TURKEY POINT NUCLEAR GENERATING UNIT NO. 3

AMENDMENT TO FACILITY OPERATING LICENSE

Amendment No. 57  
License No. DPR-31

ATTACHMENT TO LICENSE AMENDMENTS

Figure 3.2-3b

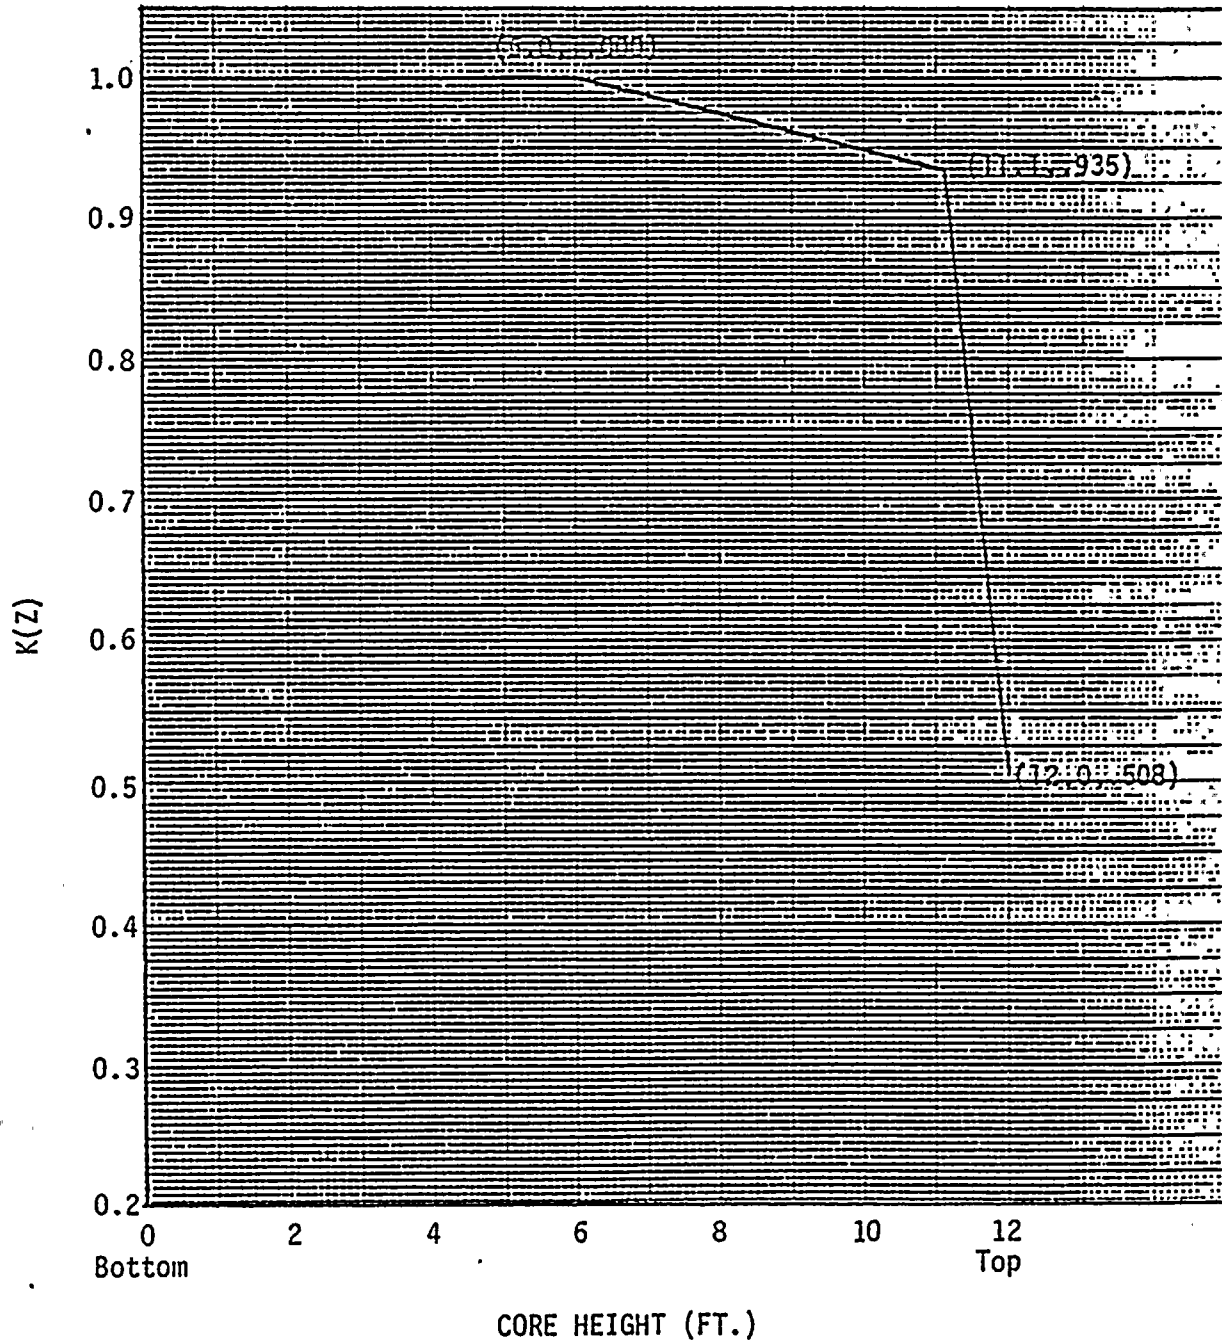
- (1) With steam generator tube plugging >22% and ≤25%, the hot channel factors (defined in the basis) must meet the following limits at all times except during low power physics tests:

$$F_q(Z) \leq (1.97/P) \times K(Z), \text{ for } P > .5$$

$$F_q(Z) \leq (3.94) \times K(Z), \text{ for } P \leq .5$$

$$F_{\Delta H}^N \leq 1.55 [1. + 0.2 (1-P)]$$

Where P is the fraction of rated power at which the core is operating; K(Z) is the function given in Figure 3.2-3b; Z is the core height location of  $F_q$ .

If  $F_q$ , as predicted by approved physics calculations, exceeds 1.97, the power will be limited to the rated power multiplied by the ratio of 1.97 divided by the predicted  $F_q$ , or augmented surveillance of hot channel factors shall be implemented.
